Subject: Amendment No. 57 to Facility Operating License No. NPF-14, Susquehanna Steam Electric Station, Unit 1

This amendment revises the Unit 1 Technical Specifications to include operational control for Cycle 3 operation.

AMENDMENT TO FACILITY OPERATING LICENSE

Amendment No. 57
License No. NPF-14

MAXIMUM AVERAGE PLANAR LINEAR HEAT GENERATION RATE (MAPLHGR) VERSUS AVERAGE BUNDLE EXPOSURE
EXXON 8X8 FUEL
FIGURE 3.2.1-2

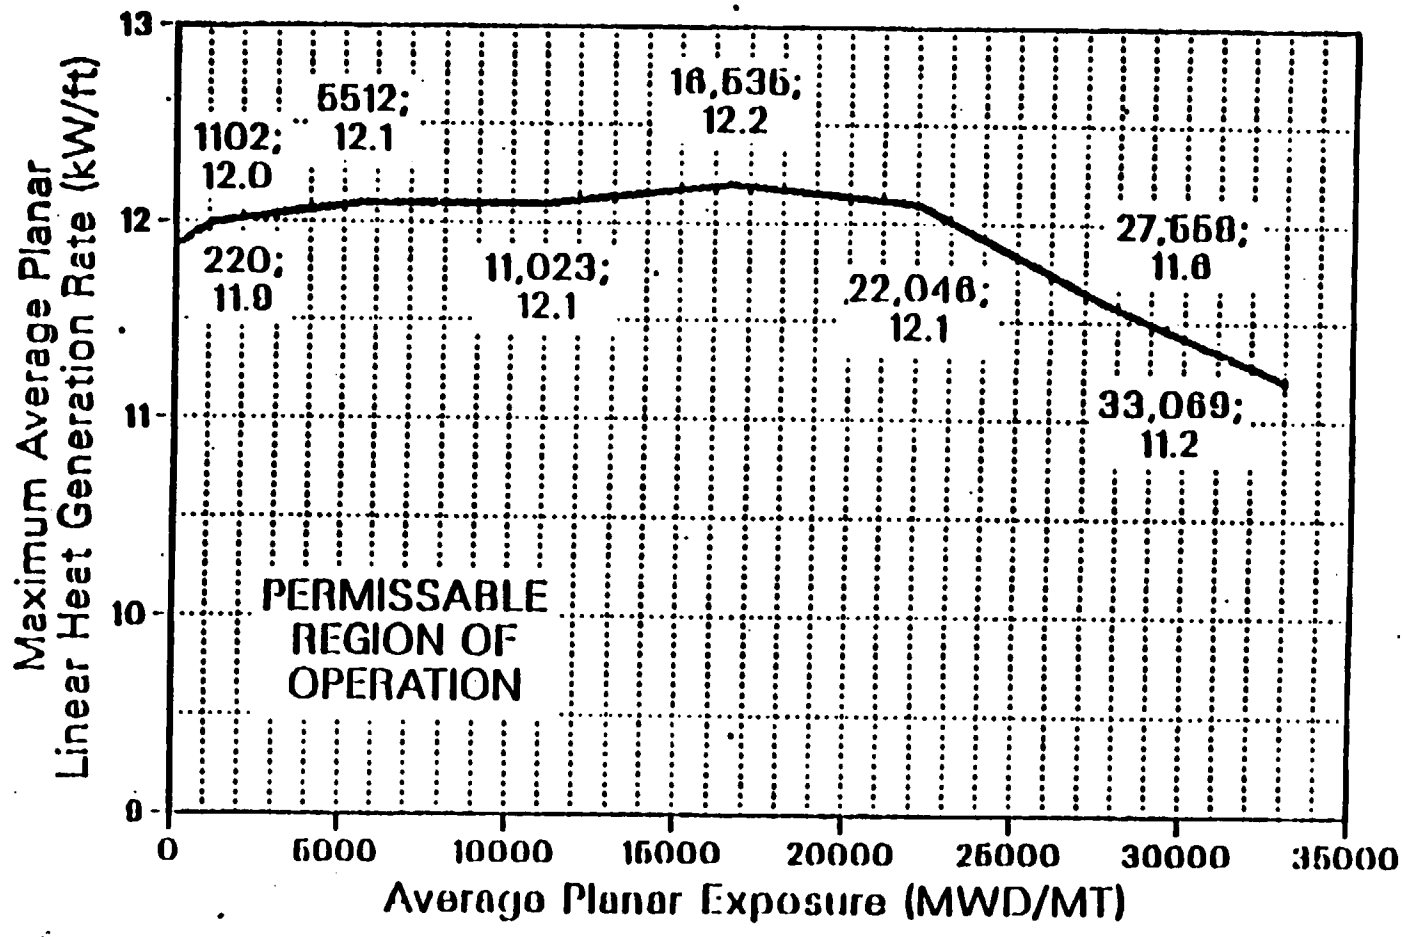
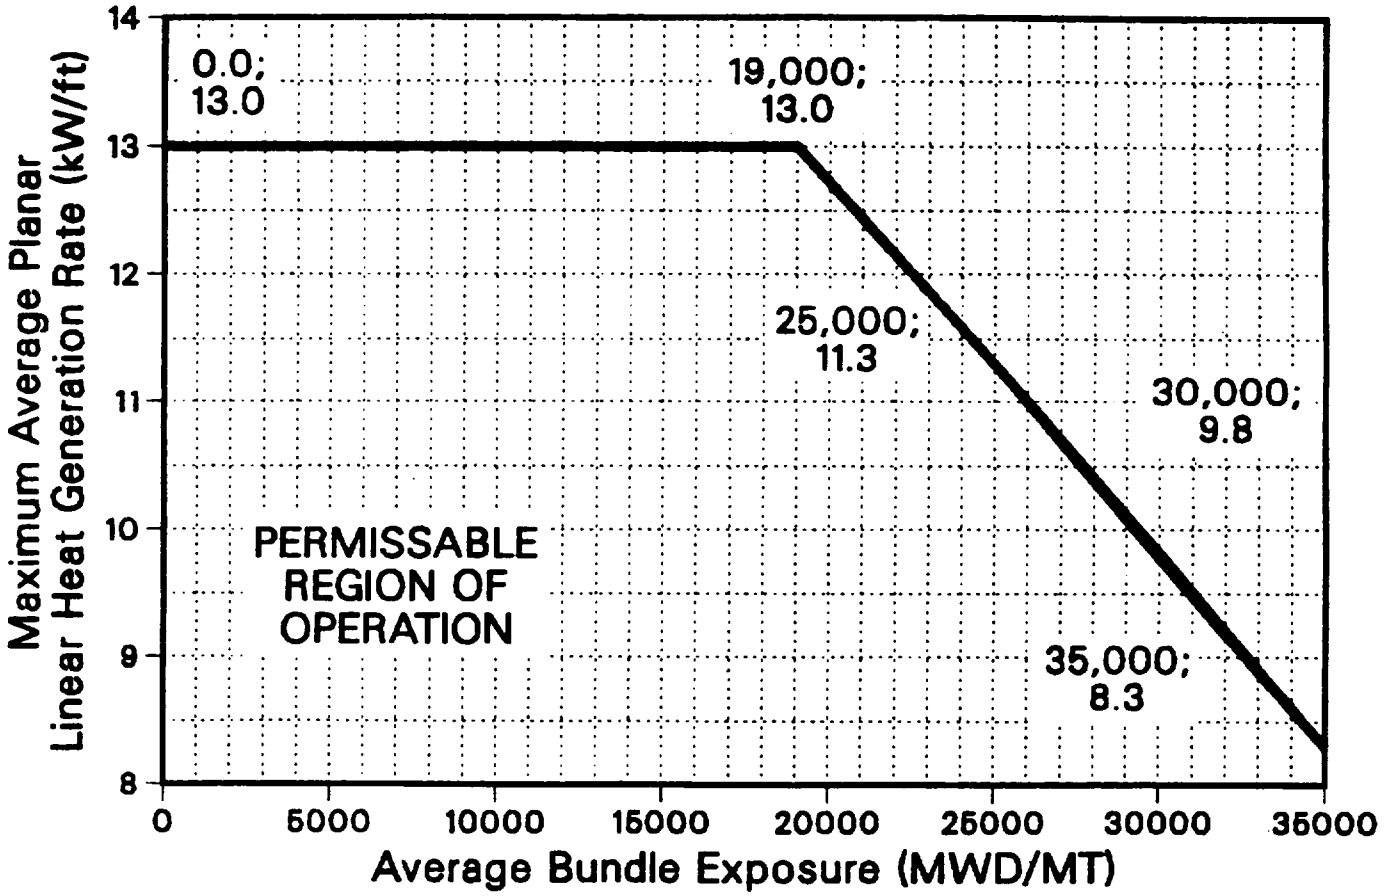
(2) 3/4.2.1 and related figures: This change removes the figure for MAPLHGR vs exposure for 1.8 percent enriched GE fuel (not used in Cycle 3) and provides a (similar) figure for Exxon 8x8 fuel for both XN-1 and

XN-2 type fuel. The Exxon figure for XN-2 fuel is the same as that used for XN-1 fuel up to 25 GWD/MTU, because the LOCA analyses for XN-2 fuel is calculated to fall within the same limits. Beyond 25 GWD/MTU the curve is more restrictive than required by the LOCA analyses in order to maintain the power history assumed in the approved mechanical design analysis. These changes are acceptable.

LINEAR HEAT GENERATION RATE (LHGR) LIMIT
VERSUS AVERAGE PLANAR EXPOSURE
EXXON 8X8 FUEL
FIGURE 3.2.4.2-1

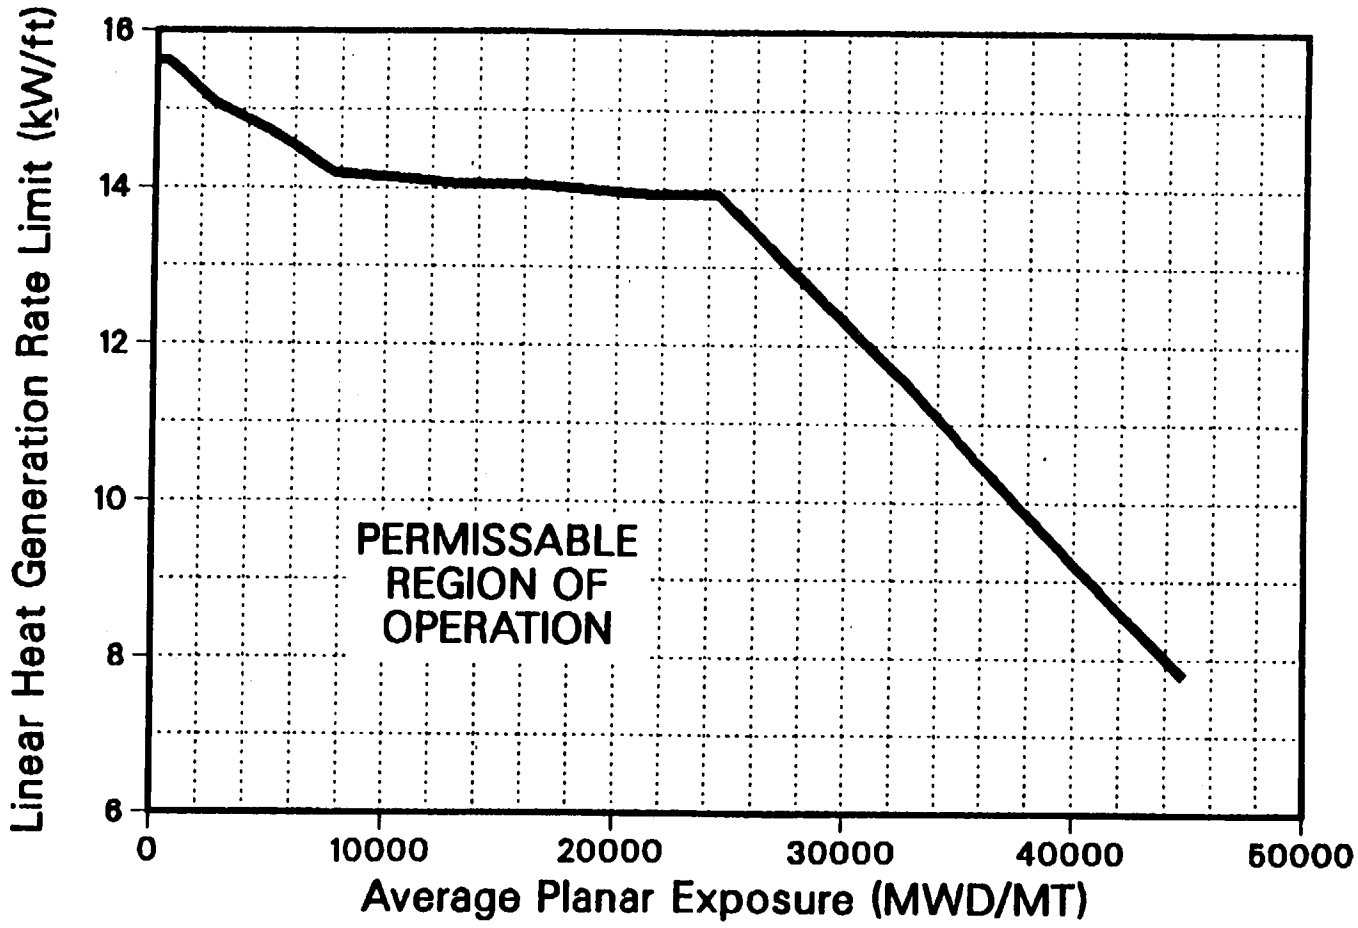
(5) 3/4.2.4.1 and .2 and Figure 3.2.4.2-1: These changes provide a LHGR limit for Exxon fuel in addition to the existing GE fuel limit. The Exxon limit is a function of exposure and provides information to find the value of T in specification 3.2.2. It is to be noted that the correct figure is provided in Reference 4. Reference 4 contains only a small correction over a limited burnup range.
